Re: Turkey Point Unit 3  
Docket Nos. 50-250  
Subsequent Renewed License No. DPR-31  
Fifth Ten-Year Inservice Inspection Interval Revised Relief Request No. 6 and  
Supplemental Information for Train B CCW Return Piping

**REVISED RELIEF REQUEST No. 6**

**Turkey Point, Unit 3**  
**Fifth 10-Year Interval Revised Relief Request No. 6**  
**Component Cooling Water Welded Repairs for External Corrosion**  
**L-2020-073**

### **Supplemental Information on Train B CCW Return Piping**

Original Grid / ZERO Reference Line (Looking West)

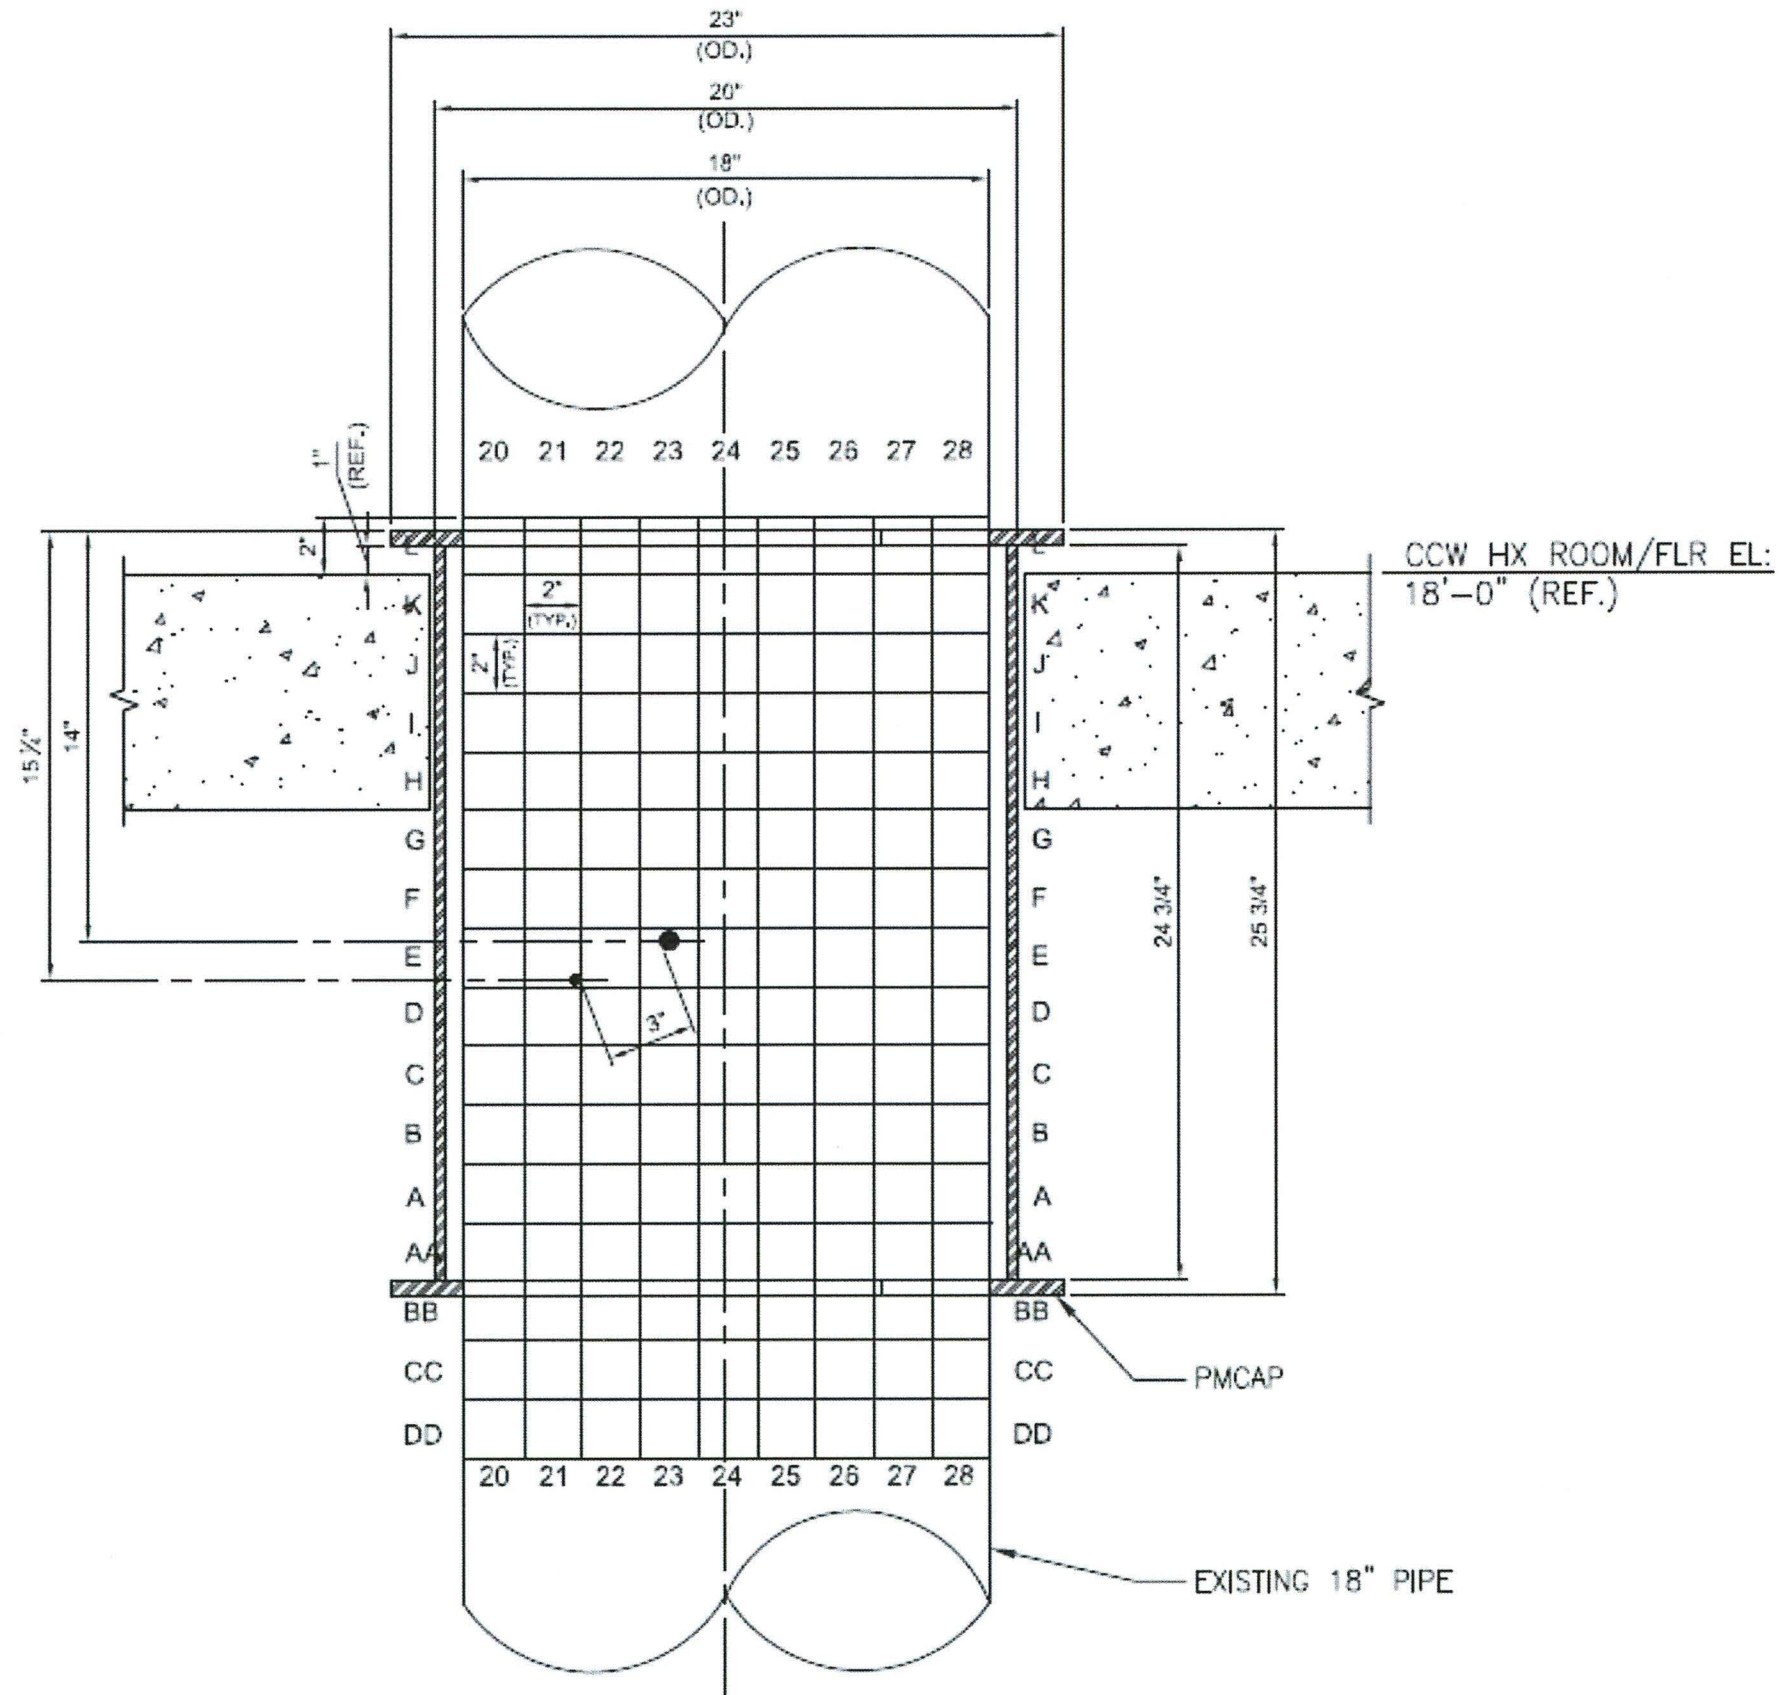
1. Provide a Map of as found pipe wall thickness and the NDE thickness profile as it applies to the total length of the PMCap
2. Drawing and design spec of the PMCap
3. Drawing showing placement of the PMCap overlaid on the pipe wall thickness
4. Weld details for the installation of the PMCap
5. NDE performed on PMCap Installation weld
6. Analysis of effect of the extra weight of the PMCap on supports
7. Future monitoring of the area
8. Justification for this being a permanent repair.

Map of as found pipe wall thickness and NDE report is enclosed in Attachment 2.

Grid was established on pipe in 2" x 2" blocks, with the extra-dose of the upstream elbow orienting the ZERO Reference Line (see Diagram 2) and labeled based upon direction of flow. Original inspection area: 360° circumferentially (1 through 29), and 24" longitudinally (A through L) ending 2" above the CCW HX Room floor (18' elevation). An additional 8" upstream (DD through AA) was added due to PM Cap alignment (see Diagram 1 & 3).

Grid location: E23 is the existing 5/8" diameter through-wall hole (Ref. AR 02350581), E21 is below screening value at 0.104", and G23 is lowest above screening at 0.109" (see Table 1). At each of these locations (E23, E21 and G23) readings were taken 1/2" on either side of the low point in both longitudinal and circumferential directions, and distances measured between where the material returns to at/above screening value (see Table 2).
